August 30, 1985

The Commission has issued the enclosed Amendment No. 89 to Facility Operating License No. DPR-35 for the Pilgrim Nuclear Power Station. This amendment consists of changes to the Technical Specifications in response to your application dated May 14, 1985. These changes incorporate revised radiological effluent and environmental monitoring limiting conditions for operation, action statements, and surveillance requirements.

PILGRIM NUCLEAR POWER STATION

Amendment No. 89
License No. DPR-35

Figure 1. Liquid Radwaste Treatment Systems, Effluent Paths, and Controls for Pilgrim Nuclear Power Station Unit 1

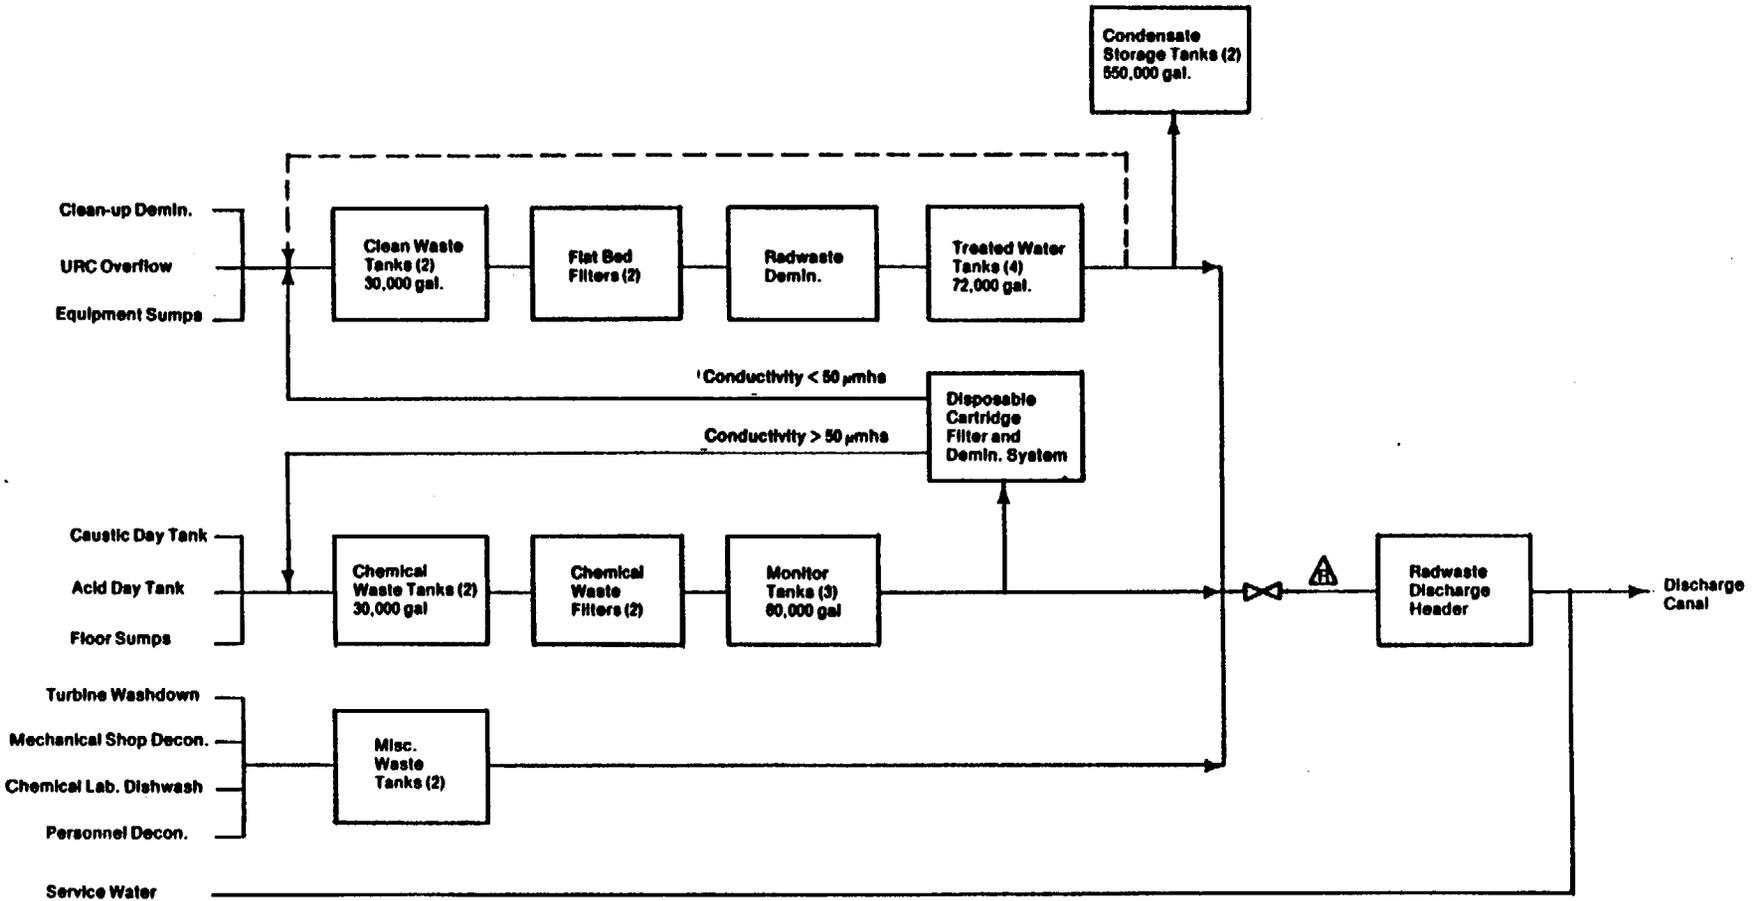
A radiation monitor has been installed for the liquid radwaste effluent line (Figure 1) which combines effluent streams from the releases of high purity wastes, low purity wastes, and detergent wastes. This monitor at the radwaste effluent line is equipped with an automatic termination function. The Licensee did not provide monitors for batch releases from the neutralizer sump and salt service water, both also merged into the discharge canal. However, the Licensee has made a commitment to perform the sampling and analysis for these two effluent lines before discharges are made. This satisfies the intent of NUREG-0473.

Figure 2. Gaseous Radwaste Treatment Systems, Effluent Paths, and Controls for Pilgrim Nuclear Power Station Unit 1

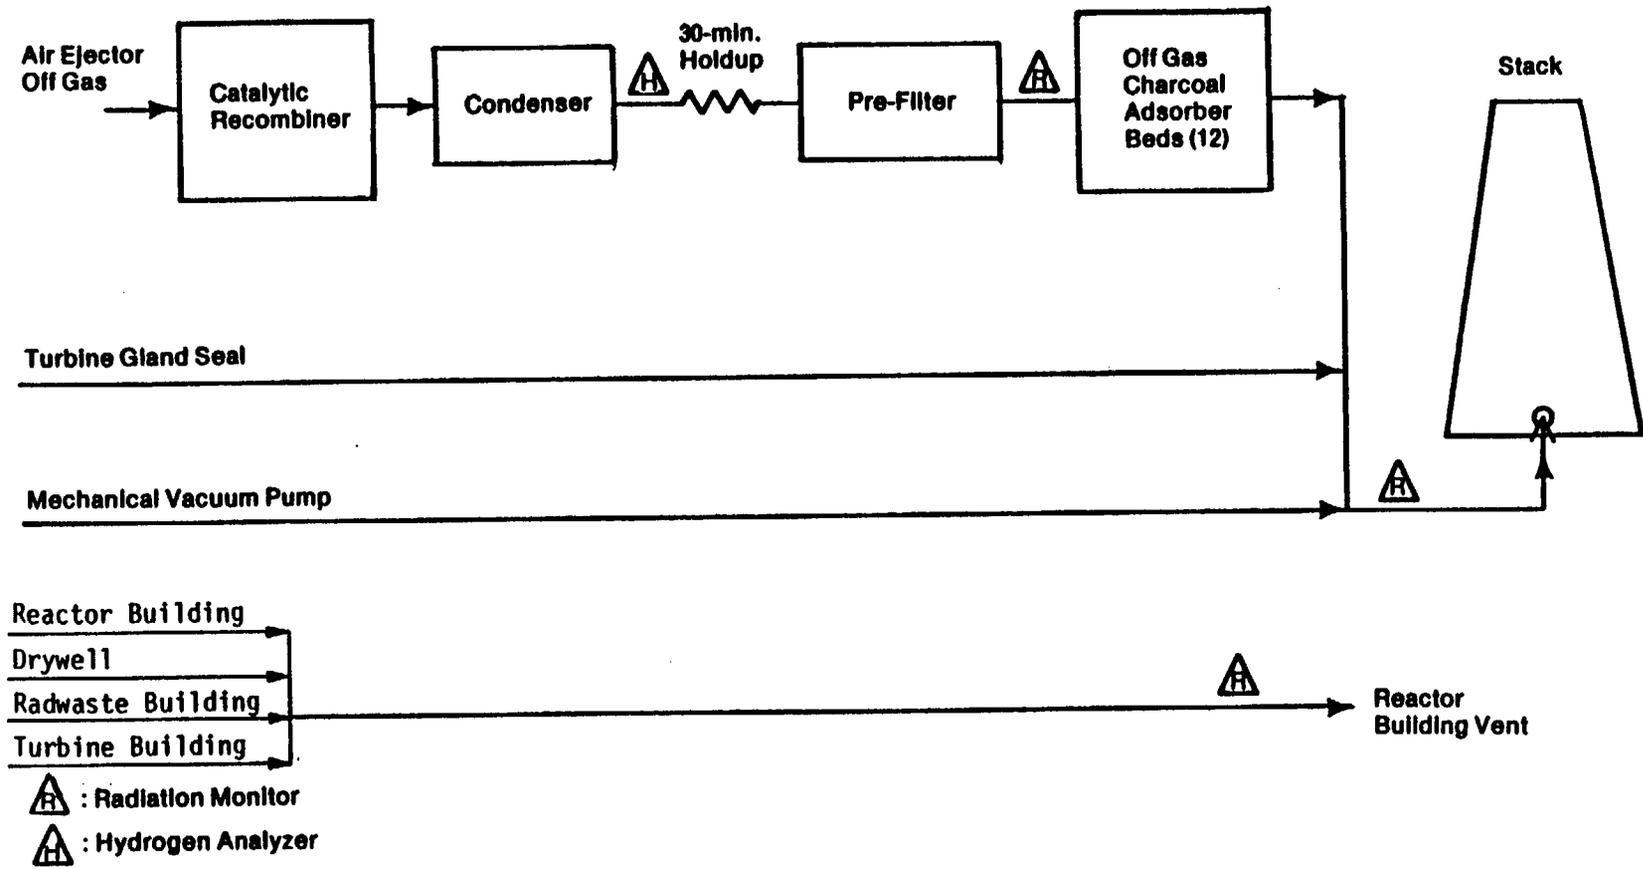
The radioactive gaseous waste sampling and analysis program (Table 4.8-3 of the Licensee's submittal) provides adequate sampling and analysis of the plant stack discharges, including the substreams, and therefore meets the intent of NUREG-0473.
